Ringsend Wastewater Treatment Plant Upgrade Project

**RE: STRATEGIC INFRASTRUCTURE DEVELOPMENT & THE PROVISIONS OF THE PLANNING & DEVELOPMENT ACTS 2000 TO 2016. REQUEST UNDER SECTION 146B (1) OF THE ACTS FOR AN ALTERATION TO THE TERMS OF THE DEVELOPMENT FOR THE PERMITTED RINGSEND WASTE WATER TREATMENT WORKS EXTENSION (AN BORD PLEANÁLA SID REF: PL29N.YA0010) AT RINGSEND WASTEWATER TREATMENT WORKS (WWTP), POOLBEG PENINSULA, DUBLIN 4.**

- **OMISSION OF THREE CONSTRUCTION SITE COMPOUNDS PREVIOUSLY APPROVED BY AN BORD PLEANALA UNDER SID REF; PL29N.YA0010, AND**
- **PROVISION OF THREE NEW TEMPORARY CONSTRUCTION SITE COMPOUNDS AT ALTERNATIVE LOCATIONS AS REPLACEMENT FACILITIES. THE PROPOSED NEW COMPOUNDS ARE LABELLED C1, C2 AND C3 ON DRAWING NO. Y15710/PL/001**

**Please Refer to Drawing Y15710/0880/PL/001**

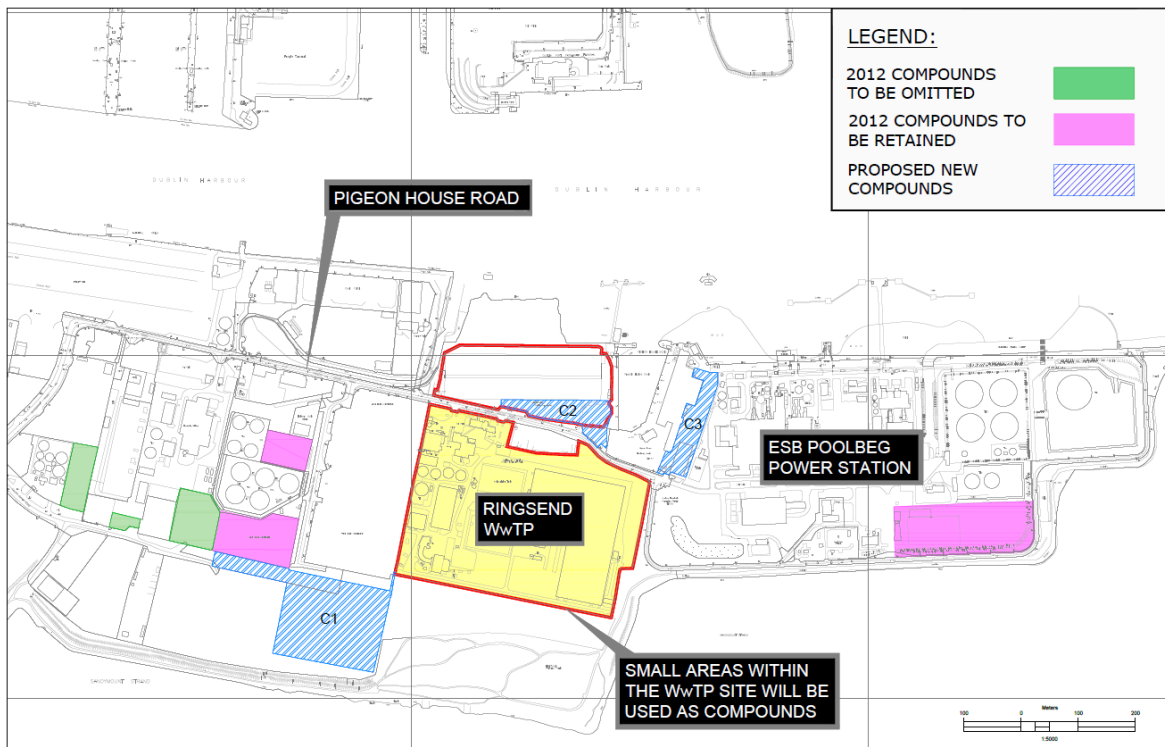
Under the 2012 approval An Bord Pleanala granted consent for the provision of six off-site construction compounds to facilitate delivery of the WwTP upgrade works. Three of these compounds remain available (locations coloured magenta on Drawing Y15170/PL/001 below). The three compounds to be omitted are marked plain green on the drawing. The proposed three new compounds the subject of this S146B application are marked blue on the drawing and labelled C1, C2 and C3.

- Omission of three approved construction site compounds, indicated on Drawing Y15710/PL/001, granted by An Bord Pleanála under ABP Ref: 29N.YA0010 to facilitate construction of the proposed Ringsend WwTP upgrade development, and
- Provision of three new temporary construction site compounds at alternative locations as replacement facilities, labelled C1, C2 and C3 on Drawing Y15710/PL/001. Full details of the proposed alterations are set out in the enclosed Project Report.
